SUBJECT: Forwards response to NRC RAI resulting from 930625 telcon re
 Topical Rept NTH-TR-01, "RETRAN Model Qualification -
 Decrease in Heat Removal by Secondary Sys."

Re: Response to Request for Additional Information Related to
Topical Report NTH-TR-01, RETRAN Model Qualification - St.
Lucie Plant Unit Nos. 1 and 2 (Docket Nos. 50-335 and 50-389)
and Turkey Point Plant Units Nos. 3 and 4 (Docket Nos. 50-250
and 50-251 (TAC Nos. 75082, 75083, 75084 and 75085))

QUESTION # 1

FIGURE 1. ST. LUCIE 1, RCS PRESSURE

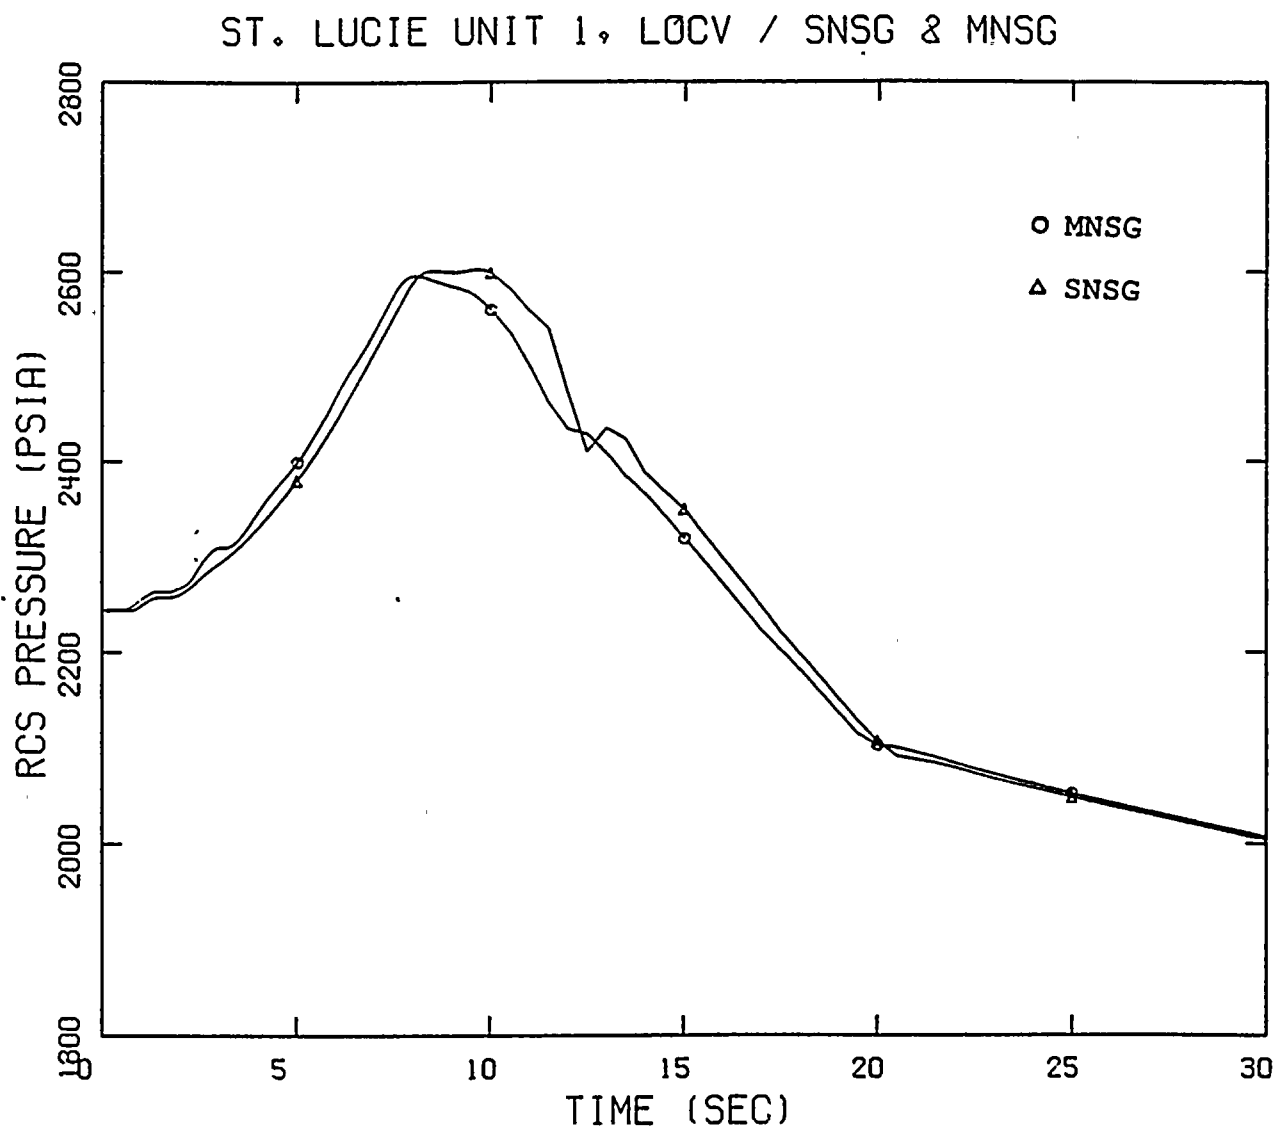
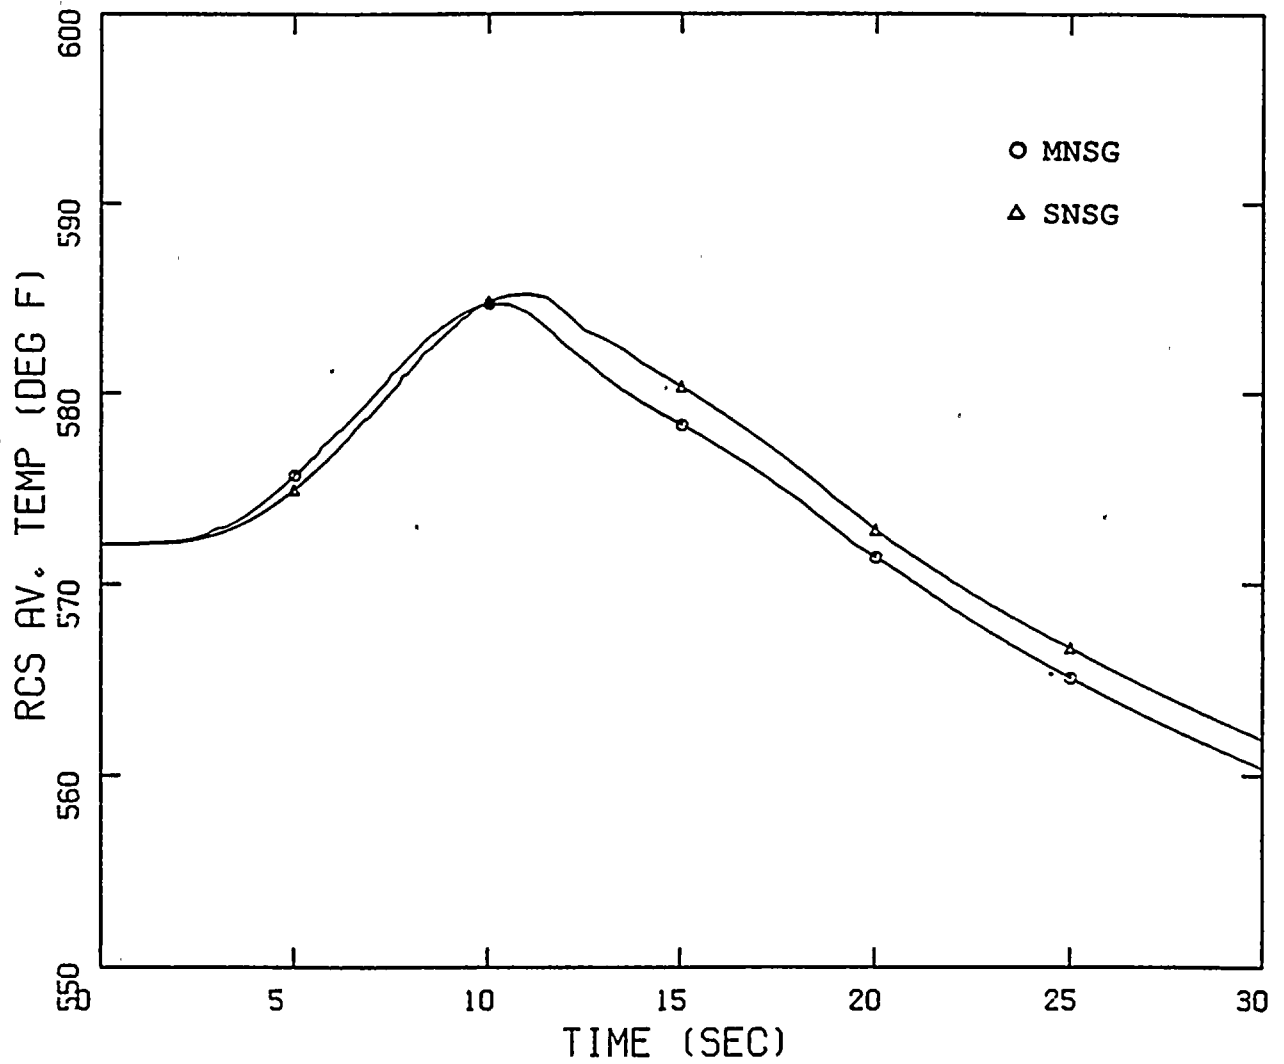
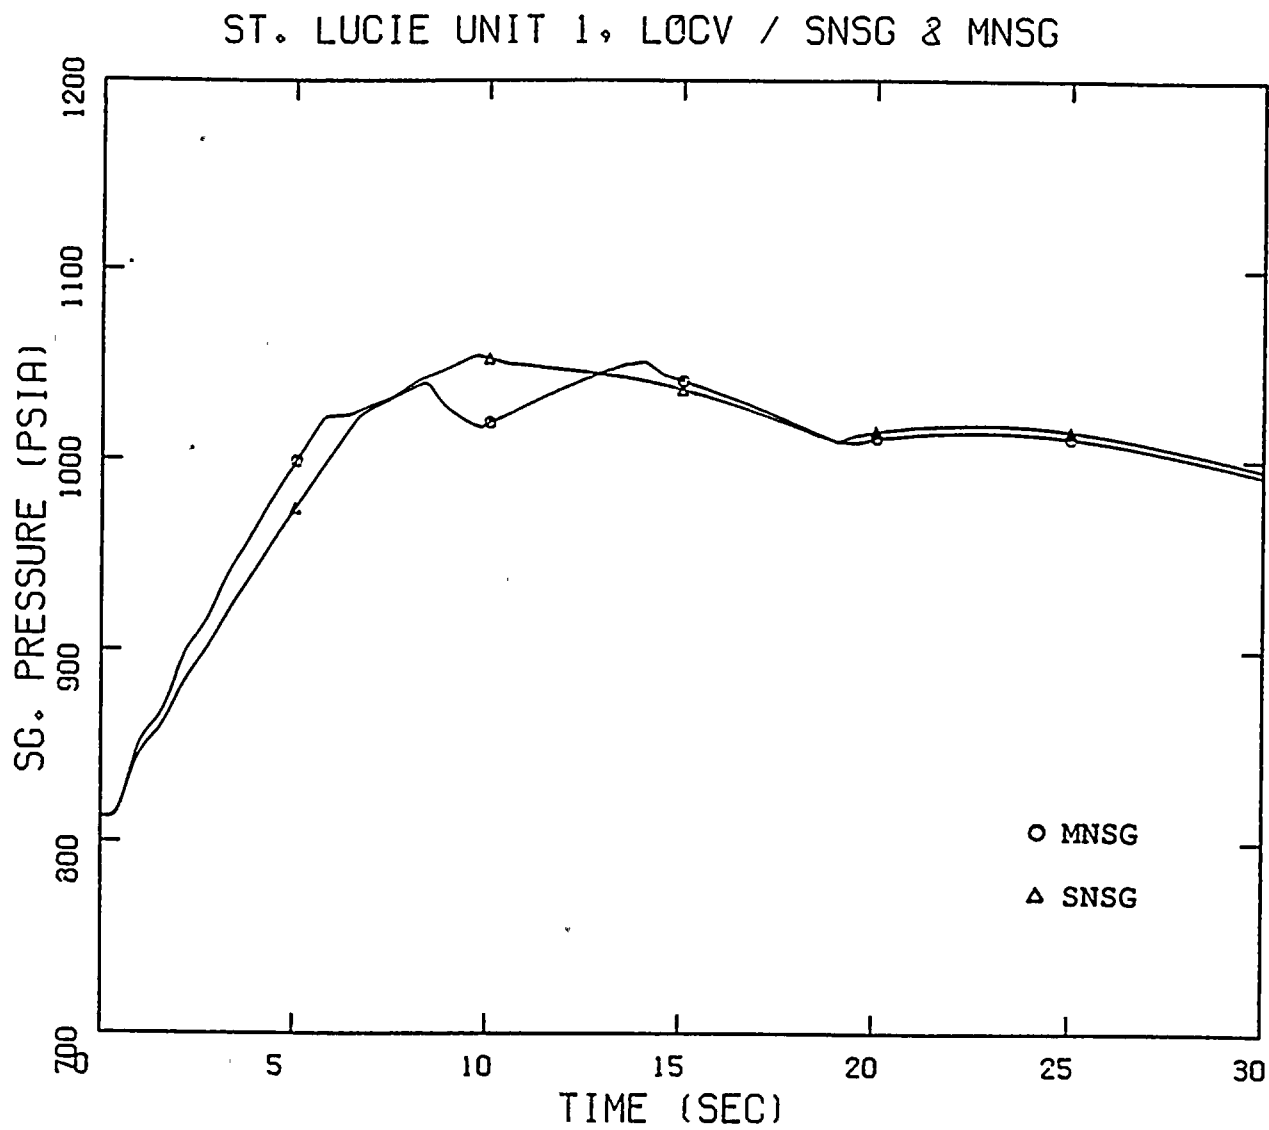
Why is the Single Node Steam Generator model adequate for W and CE plants in the Loss of Condenser type analyses. Plant differences?

Figures 1 through 3 show the comparisons of primary and secondary responses predicted with the SNSG and the MNSG for the St. Lucie Unit 1 Loss of Condenser Vacuum (LOCV) transient. Figures 4 through 6 show the corresponding comparison for the Turkey Point units. Both LOCV transients, described in detail in Reference 1, are based on conservative assumptions, such as instantaneous isolation of the feedwater flow at the beginning of the event.

The St. Lucie LOCV scenario is dominated by an early opening of the Main Steam Safety Valves (MSSVs) which precedes the reactor trip signal and pressurizer safety valve opening on high pressure. The MNSG model, with a 1-second earlier MSSV opening than the SNSG (which opens MSSVs at 6.6 seconds), results in less energy accumulated in the system and therefore less system overpressurization. The impact of this, however, is not significant. The differences in peak pressures predicted by the two models are about 7 psi for the primary system and 3 psi for the secondary system.
